Item Name: Alt High Crosstube 206L/L1/L3/L4

A	NEW ISSUE	CP	11.07.15
REV.	DESCRIPTION	BY	DATE
DESIGN		DART AEROSPACE LTD HAWKESBURY, ONTARIO, CANADA	
DRAWN			
CHECKED	ASS	DRAWING NO.	REV. A
MFG. APPR.	N/A	DSI 9565	SHEET 1 OF 1
APPROVED		TITLE	SCALE
DE APPR.		SUPPORT INSTALLATION CHANGE	NTS
DATE	11.07.15	COPYRIGHT © 2011 BY DART AEROSPACE LTD <small>THIS DOCUMENT IS PRIVATE AND CONFIDENTIAL AND IS SUPPLIED ON THE EXPRESS CONDITION THAT IT IS NOT TO BE USED FOR ANY PURPOSE OR COMMUNICATED TO ANY OTHER PERSON WITHOUT WRITTEN PERMISSION FROM DART AEROSPACE LTD</small>

DRAWING NO. D206-667-243	TITLE CROSSTUBE ASS'Y (206L HIGH AFT)	REV. C	DART AEROSPACE LTD ENGINEERING ORDER		D.E.O. NO. D206-667-243-C-1	SHEET NO. SHEET 1 OF 1	SCALE NTS
DRAWN 97	CHECKED ASS	MFG. APPR. RB	APPROVED MD		DE APPR. H		
DATE 11.07.15	DATE 11.07.20	DATE 11.07.21	DATE 11/07/21		DATE 11.07.21

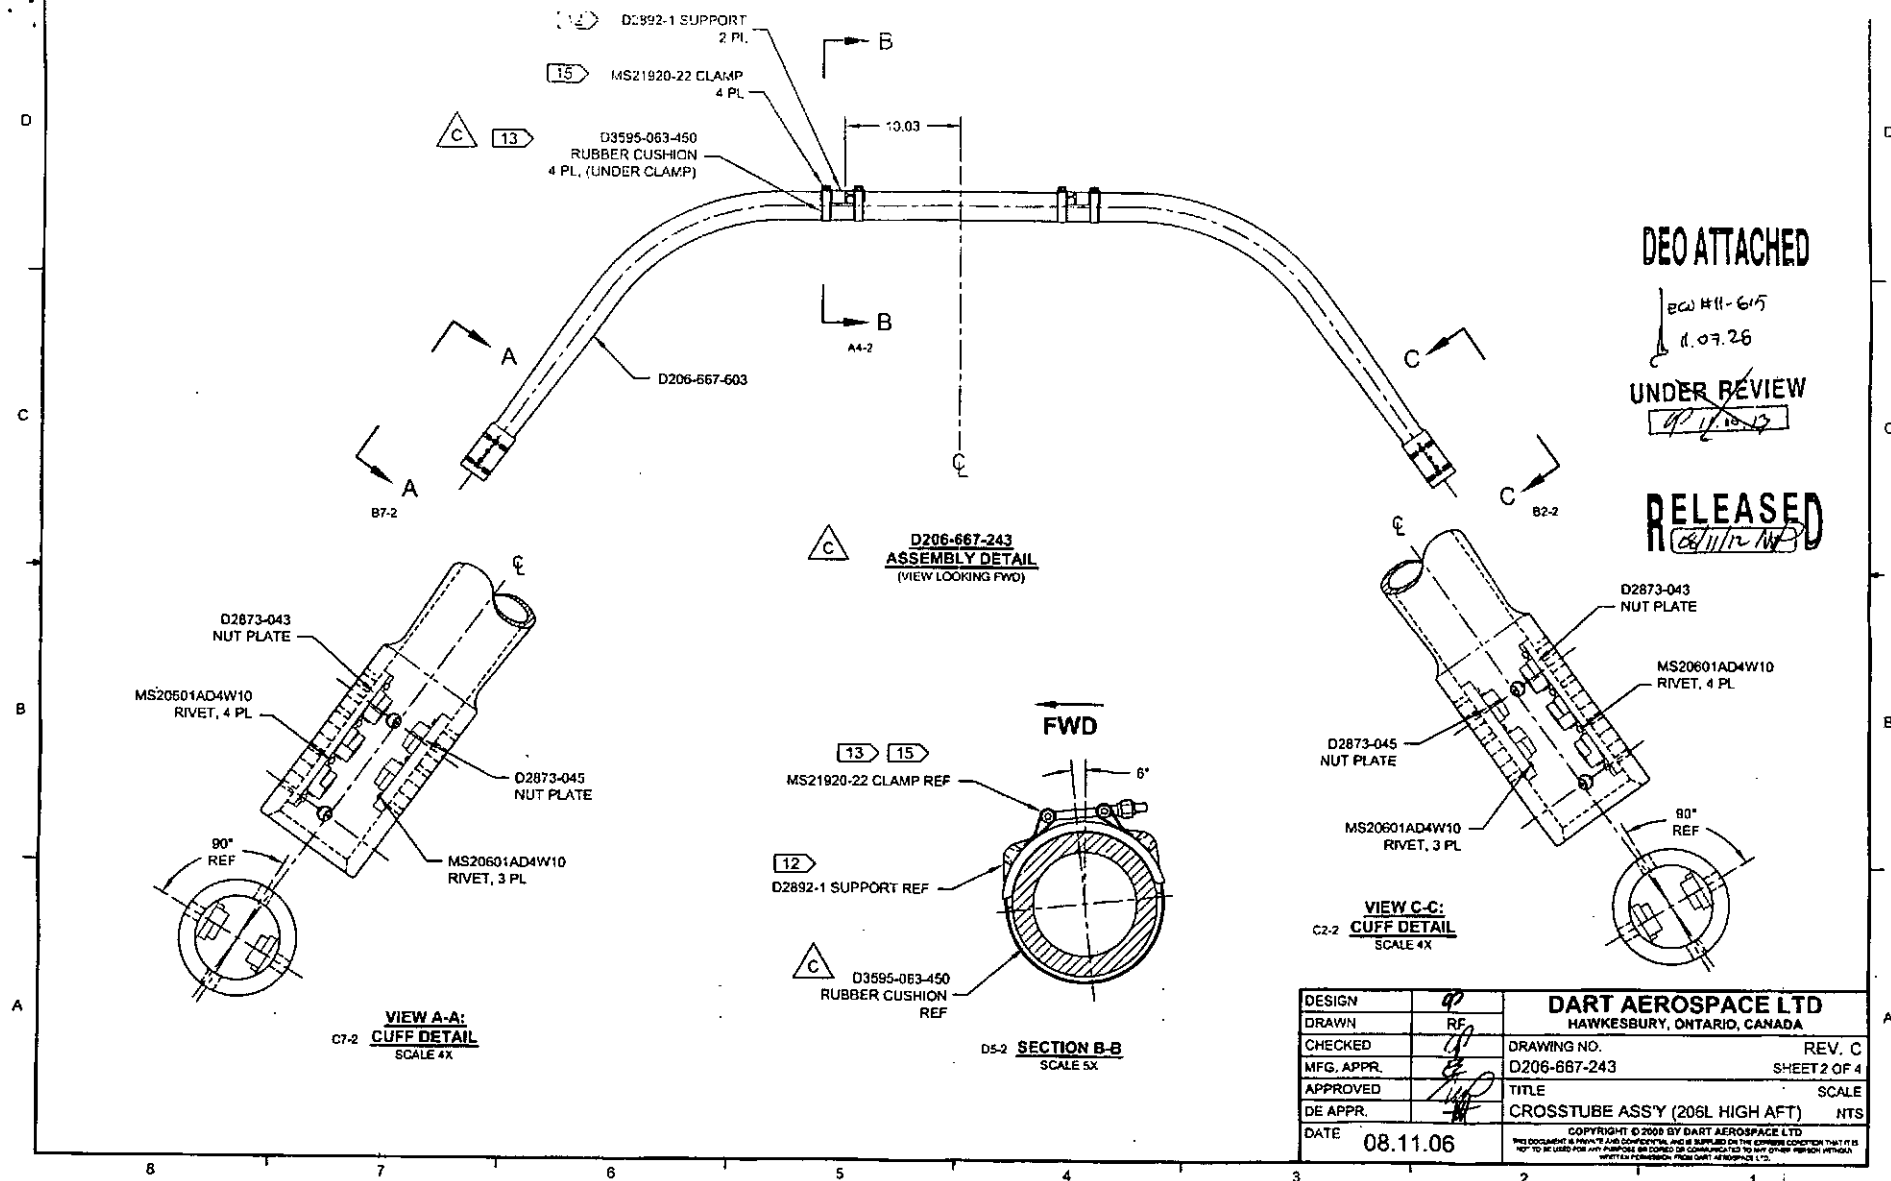
REPLACE MAGNOBOND WITH PROSEAL.

NOTE 12 & 15, SHEET 1 IS AMENDED AS FOLLOWS:

- 12) TO INSTALL D2892-1 SUPPORT: ABRASE MATING SURFACE OF SUPPORT AND CROSSTUBE WITH 180-GRIT SANDPAPER AND REMOVE RESIDUE WITH MEK (OR EQUIVALENT). APPLY A 0.04" TO 0.07" THICK LAYER OF PROSEAL 890 CLASS B-2 (OR AMS-S-8802 CLASS B-2) SEALANT TO MATING SURFACE OF SUPPORT.
- 15) TORQUE CLAMPS 80 TO 100 IN.-LB. ENSURE AT LEAST 1.5 THREADS SHOWING IN SAFETY AND THAT NUT HAS NOT BOTTOMED-OUT AFTER TORQUING. **PRIOR TO PACKAGING, RE-CHECK TORQUE ON CLAMPS AFTER PROSEAL 890 SEALANT HAS CURED FOR 72 HOURS.**
